Department of Planning and Zoning

TO: Development Review Board
FROM: Scott Gustin *SG*
DATE: March 18, 2014
RE: 14-0770SP; 421 Shelburne Street

Request: Sketch plan review of renovation and adaptive reuse of existing building as multifamily residential use.

421 SHELburne STREET | Burlington, VT
Site Plan scale: 1" = 30'-0"

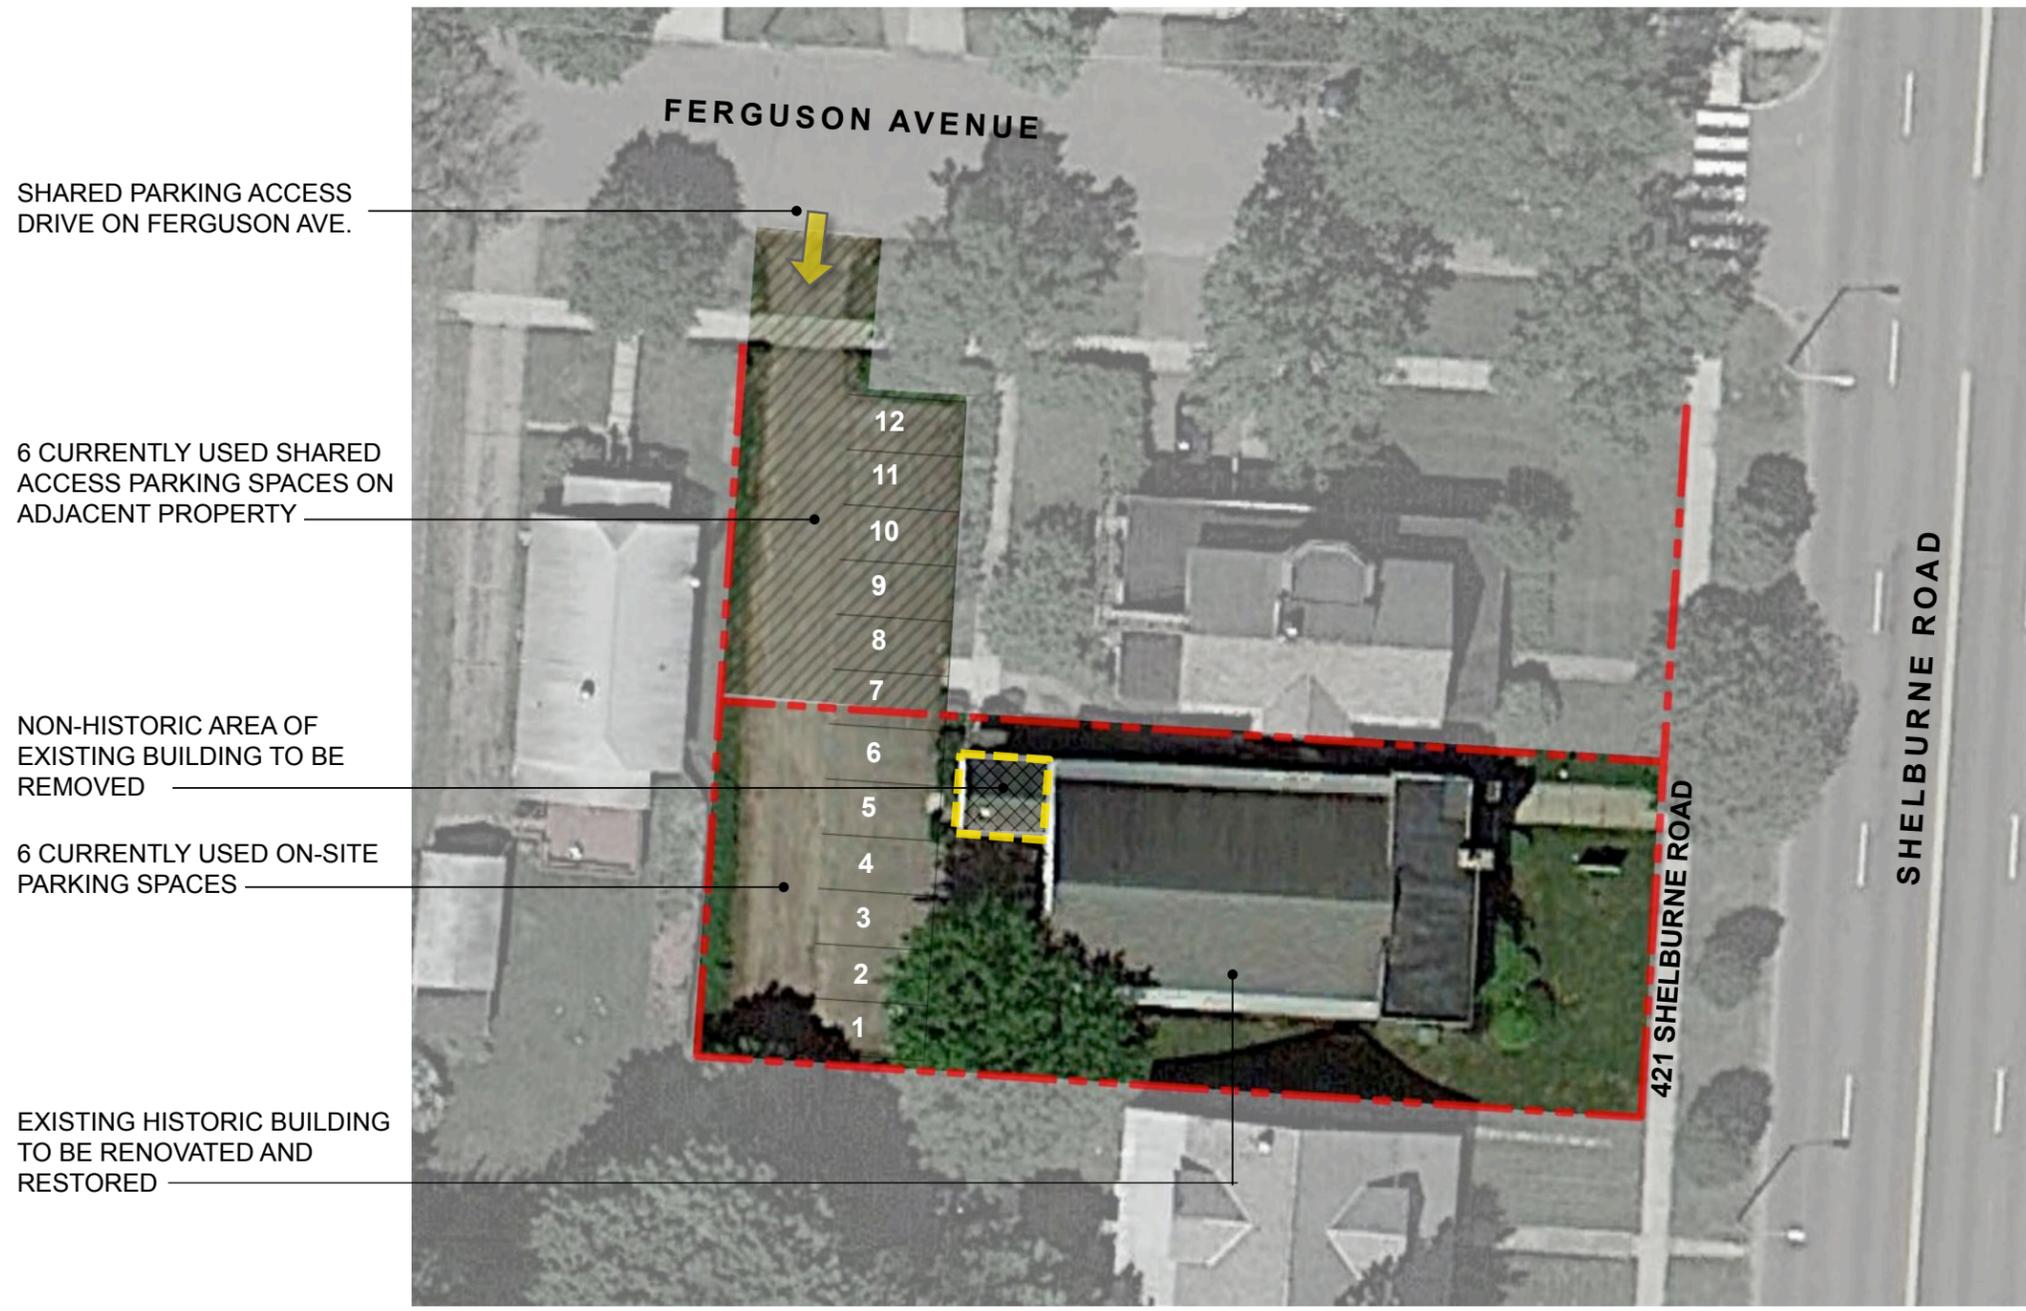
Limited site changes are proposed and are limited to the removal of an enclosed rear building entry. Details are lacking as to what will become of this area. Such details will be needed with the formal permit application.

The subject property is located in the neighborhood parking district. As a result, each dwelling unit requires 2 parking spaces – a total of up to 20 parking spaces in this case (assuming the maximum proposed 10 dwelling units). Only 6 parking spaces are actually available onsite. A parking waiver is requested per Sec. 8.1.15 below.

A parking management plan has been submitted. The management plan refers to the “right” to use at least two additional parking spaces on the adjacent property portion of the 12-space shared parking lot. The adjacent property which shares the parking lot contains a triplex. As such, it requires all 6 parking spaces on its portion of the shared lot. Nothing in the zoning permit record indicates a parking waiver for the triplex. There are no spare spaces under the standards of Sec. 8.1.8. The parking management plan goes on to note the potential 100% waiver for adaptive reuse projects, its proximity to shops, services, and transit, and the small studio unit types. It also notes that offstreet parking would not be included in the rents. Indeed, the property is located close to shopping and services in both Burlington and South Burlington. A CCTA stop is located in front of the building. Small studio dwelling units are more apt to be occupied by one person than larger units. Separating offstreet parking from the basic rent eliminates the expectation that each dwelling unit will contain a private parking space. Collectively, these items favor a parking waiver of 50% - 1 space per dwelling unit. To go beyond 50% to the full 70% waiver that would be needed for 10 dwelling units, the parking management plan needs to enable alternative transportation options for tenants beyond simply being close to a bus stop. The parking management plan needs to provide assurance that actual vehicle ownership among tenants will be equivalent to, or less than, available onsite parking. A management plan that actually provides

421 SHELBURNE STREET | Burlington, VT
OPTION 'B': Ground Floor Plan scale: 3/16" = 1'-0"

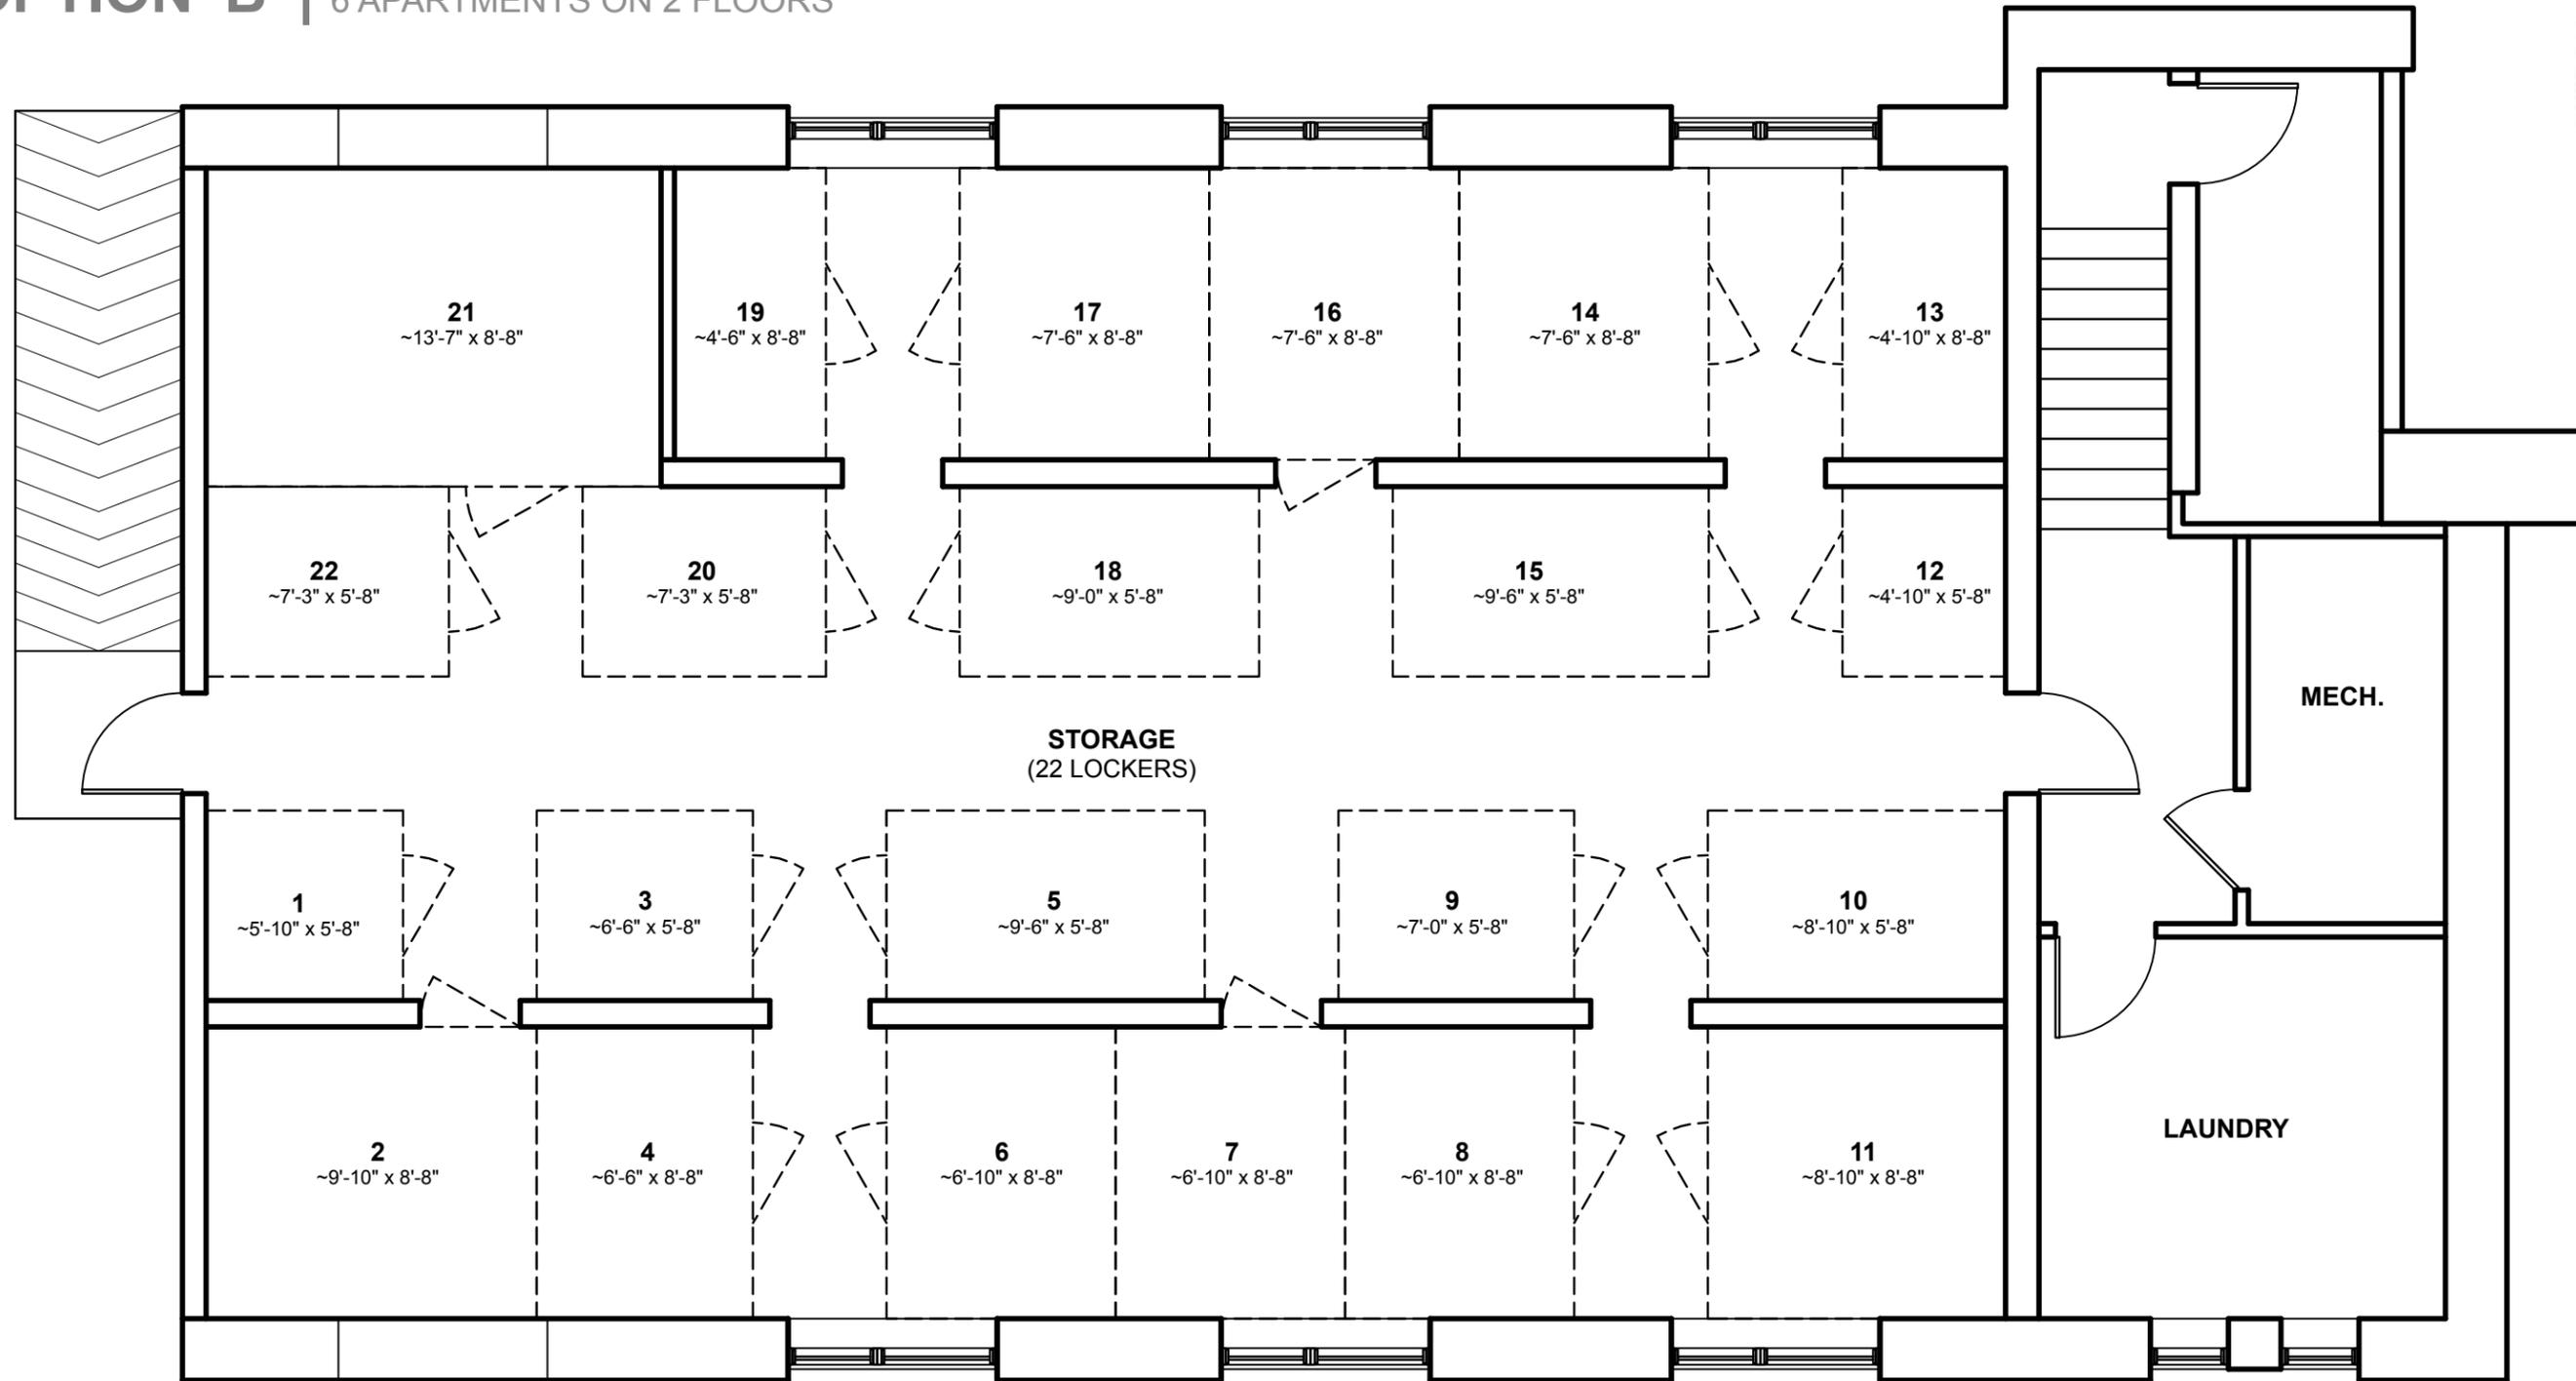
The multi-family apartment building is a permitted use in the RM zone. As an adaptive reuse project, it is subject to conditional use review. So-called Option B, with 6 apartments and a basement storage facility, would not be permitted. Self-storage facilities are not allowed in the RM zone, nor are they a “neighborhood commercial use” as defined in Article 13 of the Comprehensive Development Ordinance.
